MAYOR AND COUNCIL COMMUNICATION

AGENDA ITEM: Hammes 2nd Addition Final Plat
SUBMITTED BY: Stephen Wensman, Planning Director
THROUGH: Kristina Handt, City Administrator
REVIEWED BY: Emily Becker, City Planner
Jack Griffin, City Engineer
Mike Bent, Building Official
Sarah Sonsalla, City Attorney
Greg Malmquist, Fire Chief

A RESOLUTION APPROVING A FINAL PLAT FOR HAMMES ESTATES 2ND ADDITION

To: John Bender, P.E., Westwood Professional Services Re: Hammes Estates 2nd Addition
Cc: Stephen Wensman, Planning Director Construction Plan Review
Chad Isakson, P.E., Assistant City Engineer
From: Jack Griffin, P.E., City Engineer

HAMMES ESTATES 2ND ADDITION

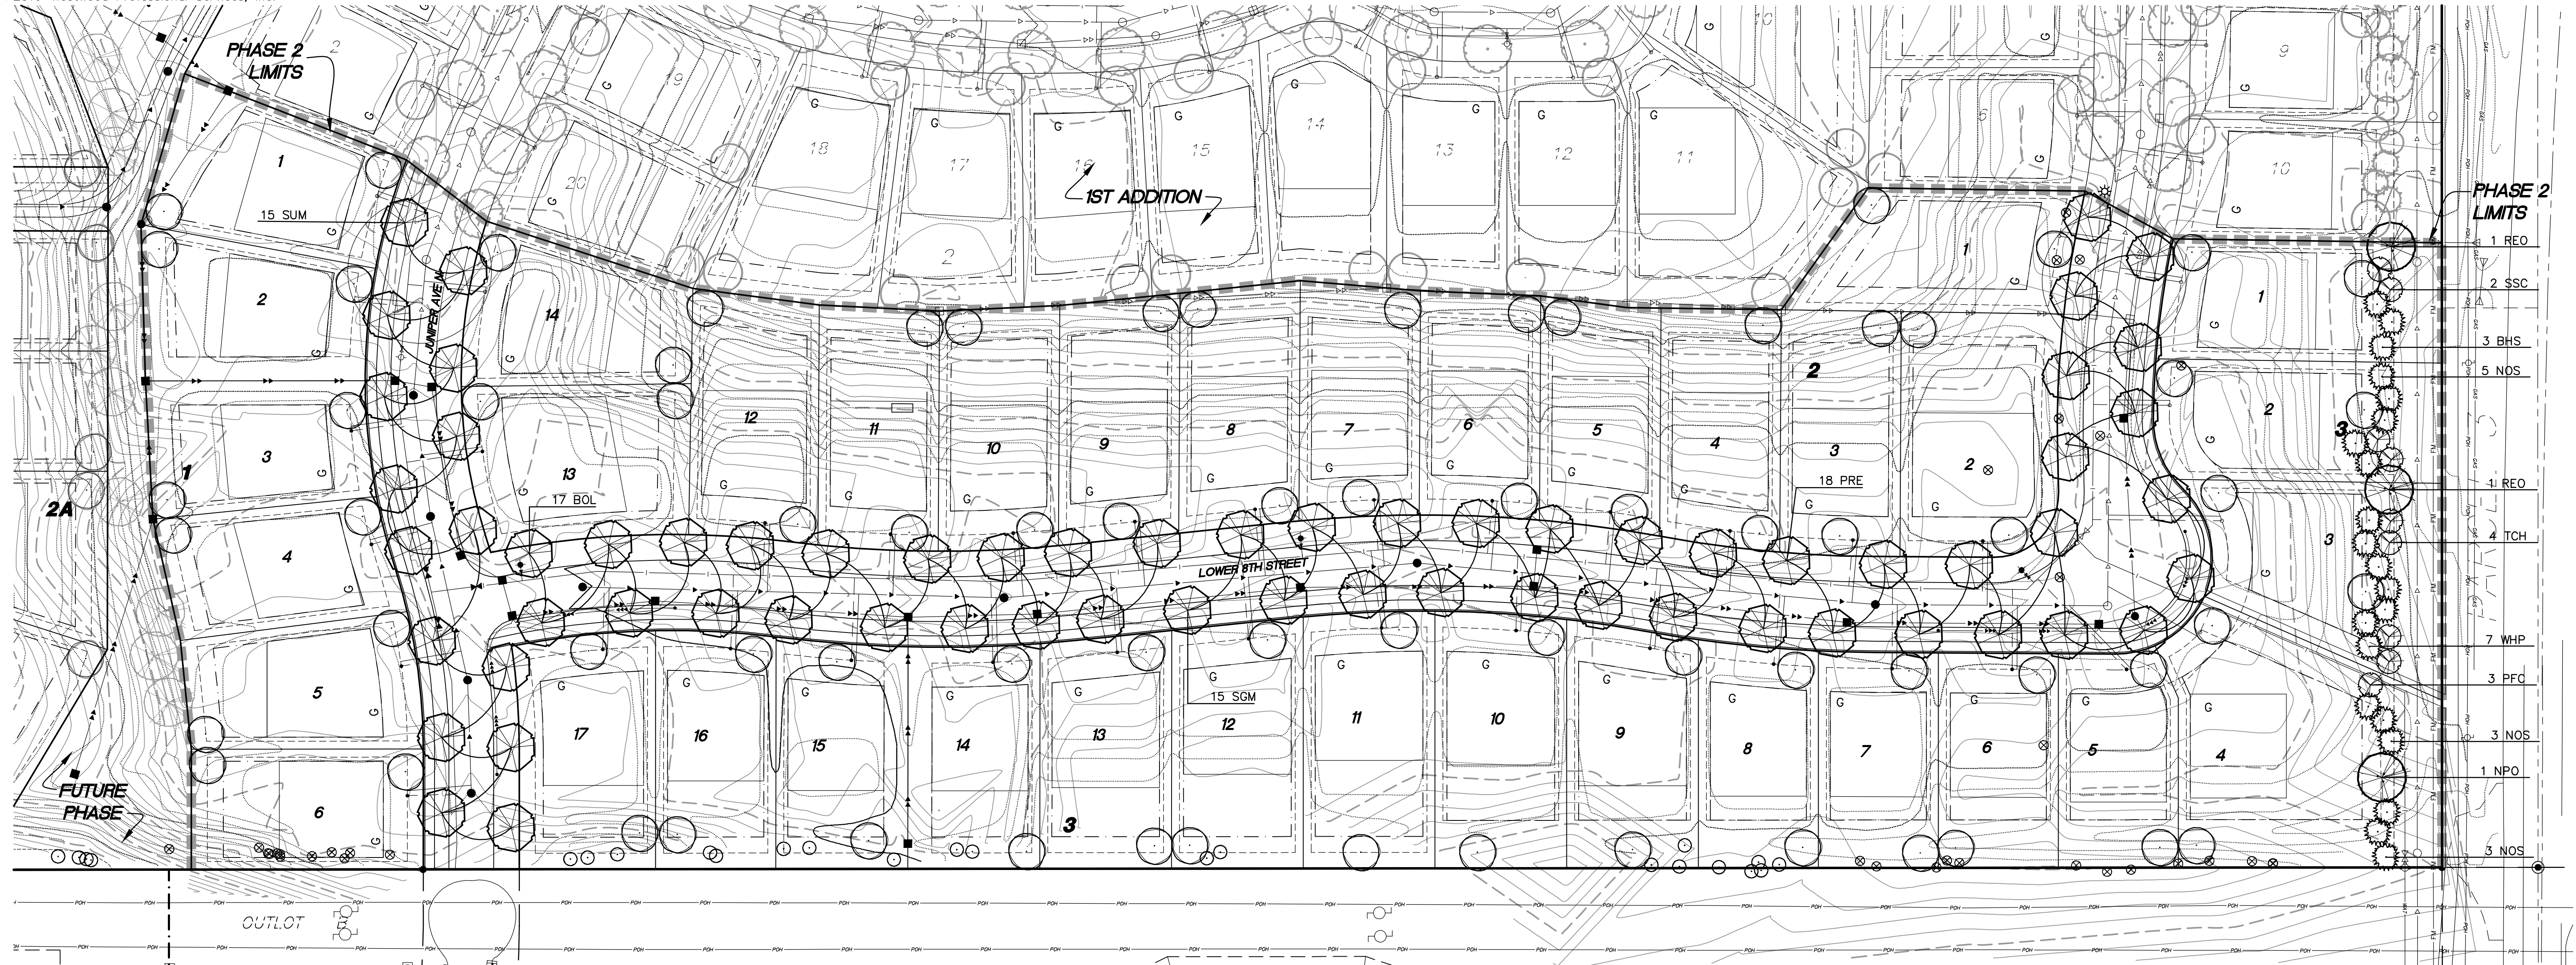
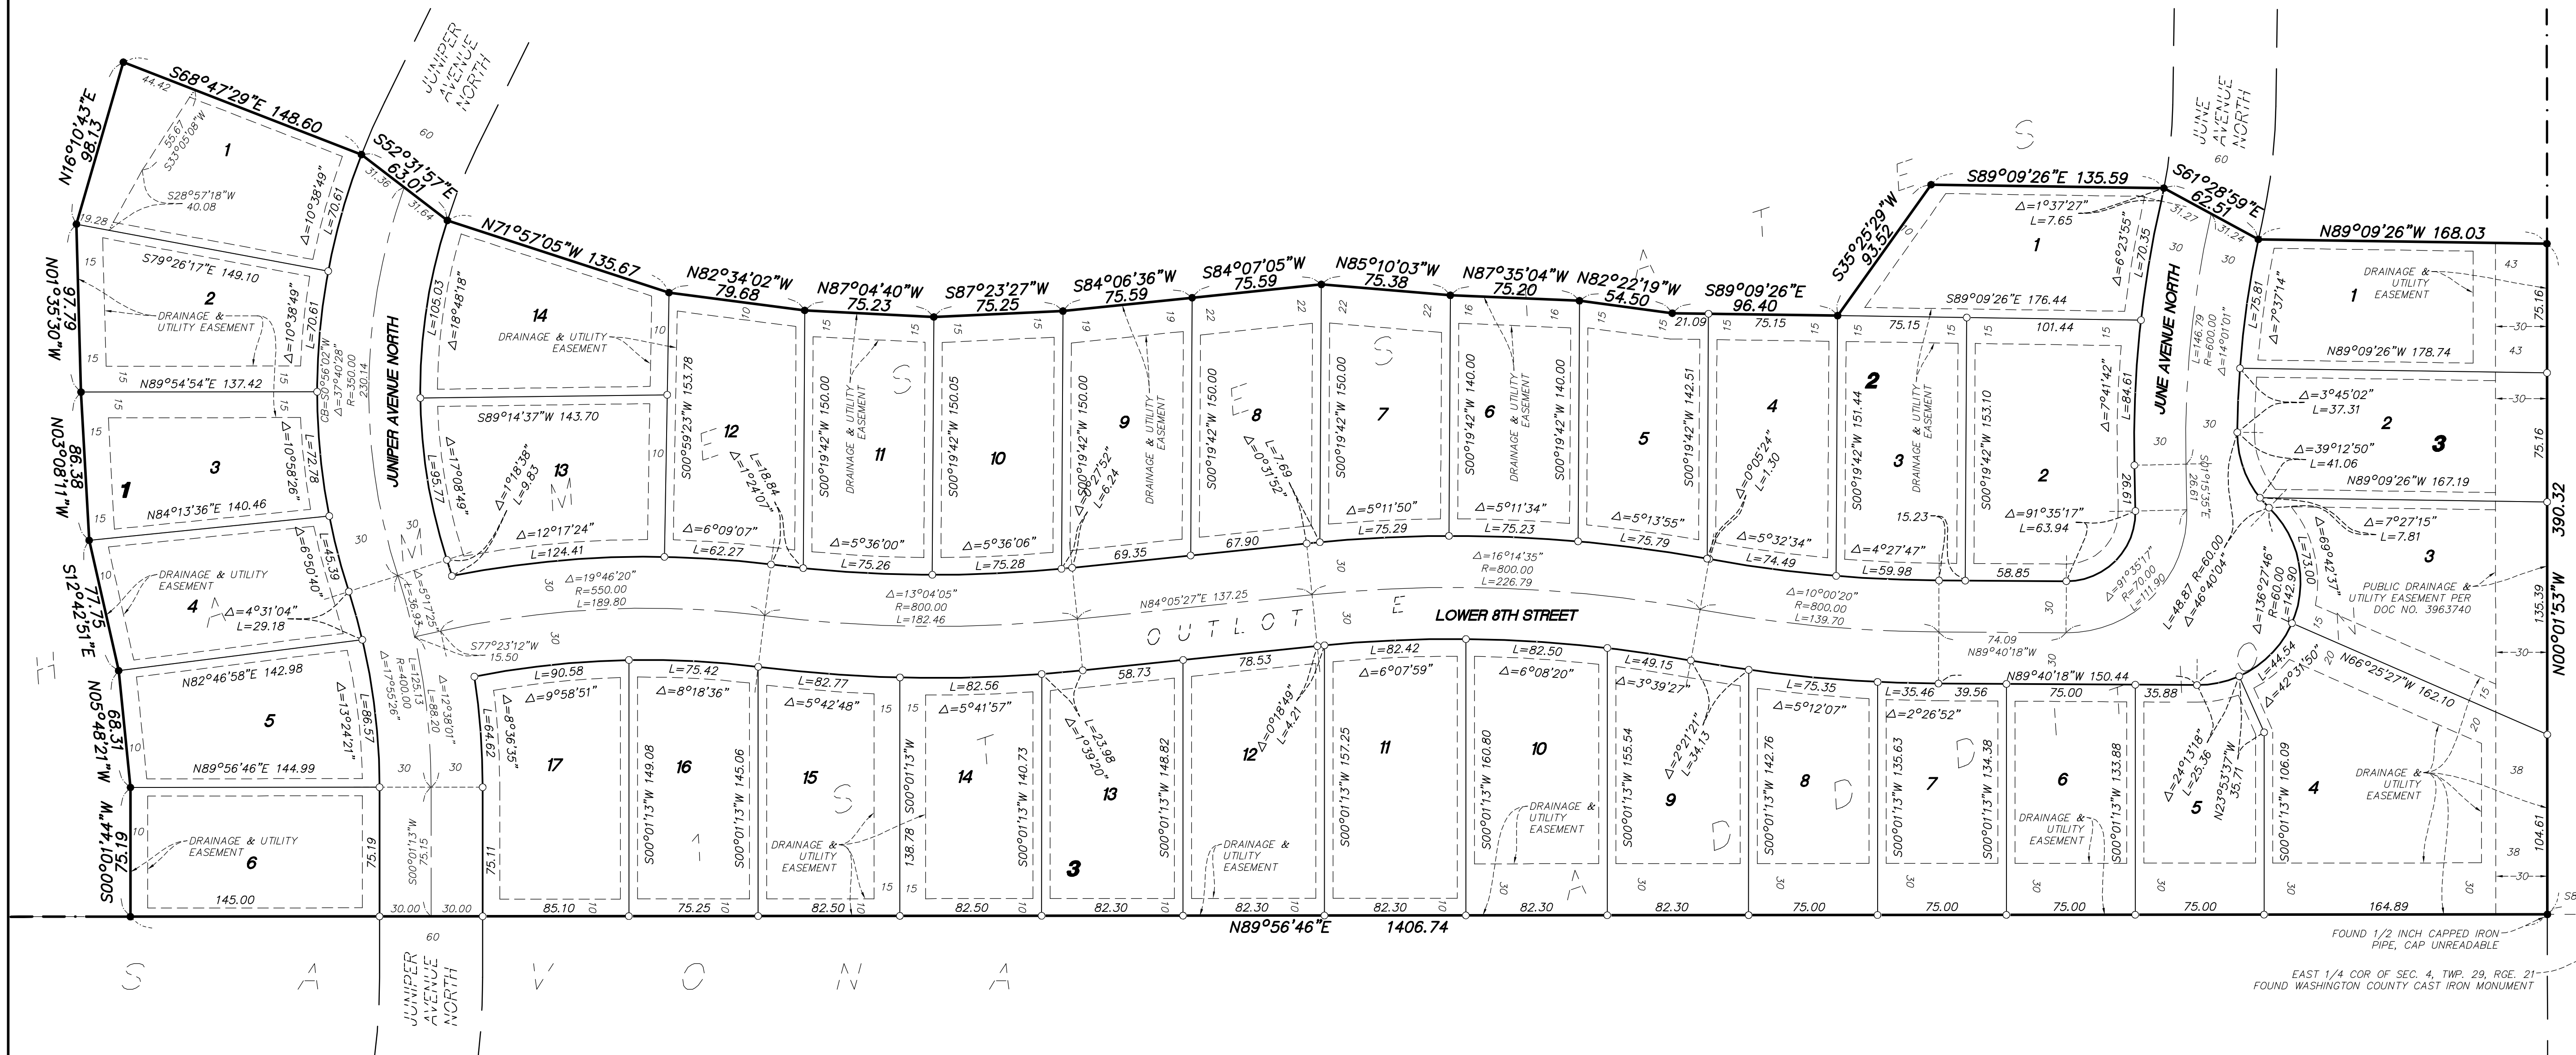
- Additional drainage and utility easement is required for Lot 4, Block 1 to provide a minimum 15 feet separation from the catch basin located at the northwest corner of the lot.

- A minimum 15 foot side lot drainage and utility easement is required along the south property line of Lot 1, Block 2 to provide a minimum 15 foot separation from the existing storm sewer pipe.

Final Landscape Plan

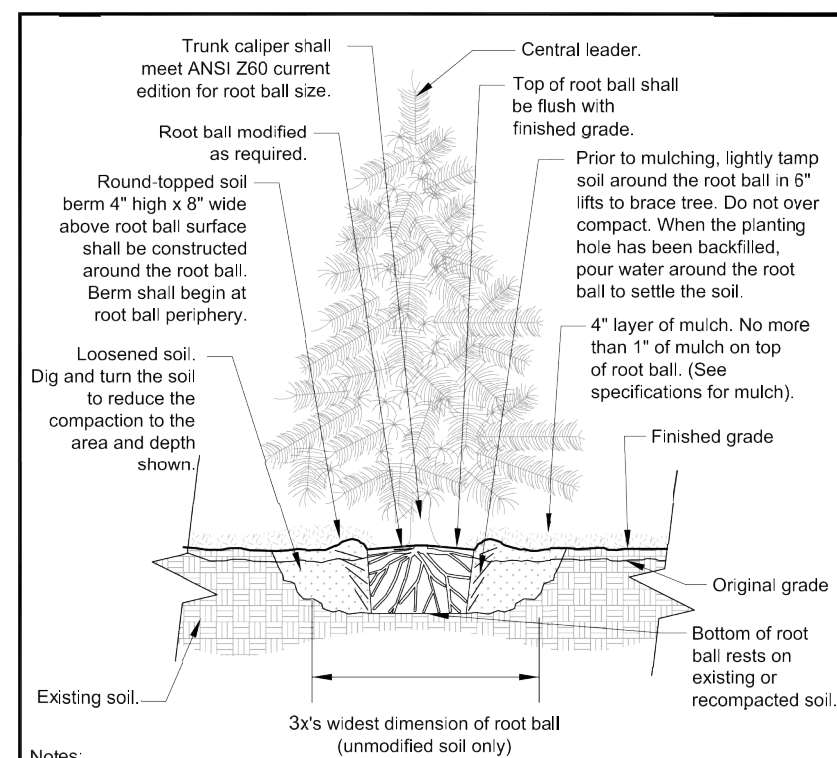
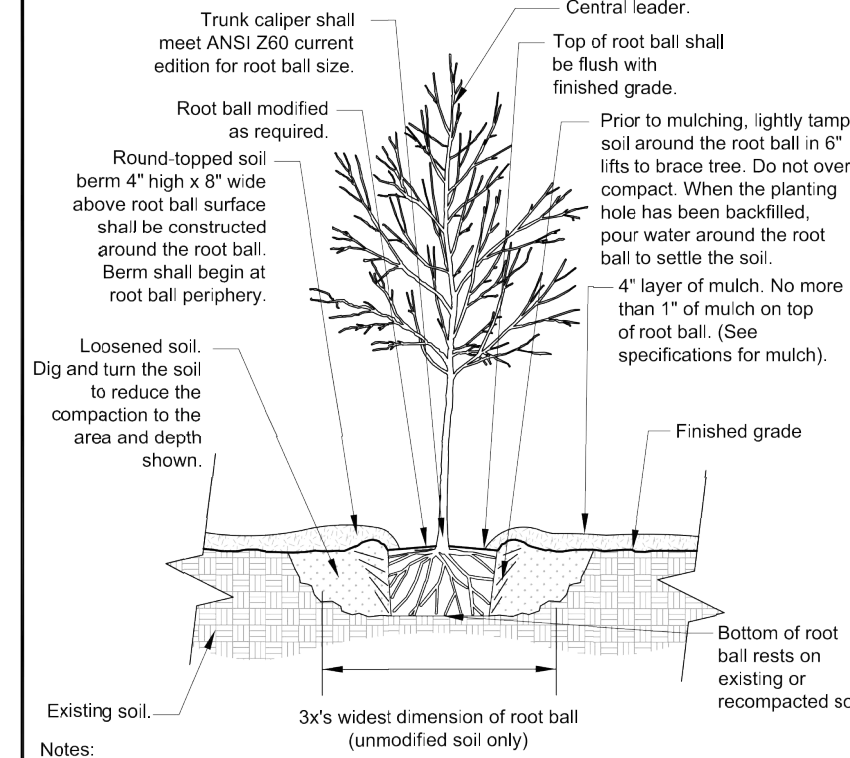
- This review does not cover the Landscape Plan or Irrigation Plan. Plan review to be completed by other City representatives.
- Landscape Plan must include a Plan Note that tree locations must be field located and inspected by City prior to install.

- The trees along the rear lot lines in Block 3 should be moved out of swales (drainage ways).
- The Final Plat Schedule lists multiple varieties of trees, but the symbols on the plans are generic and do not reflect the varieties specified in their proposed locations.

- There will be some changes to the easements on the plat and to the Construction Plans. Please update the Landscape Plans to be coordinated with any changes after the development team gets the City Engineer's comments.

- The grading shown on the Landscape Plans in the rear of Block 3 appear different than the proposed grading on the other Construction Plans.
- Sugar Maples do not make good street trees unless irrigated. Please revise.
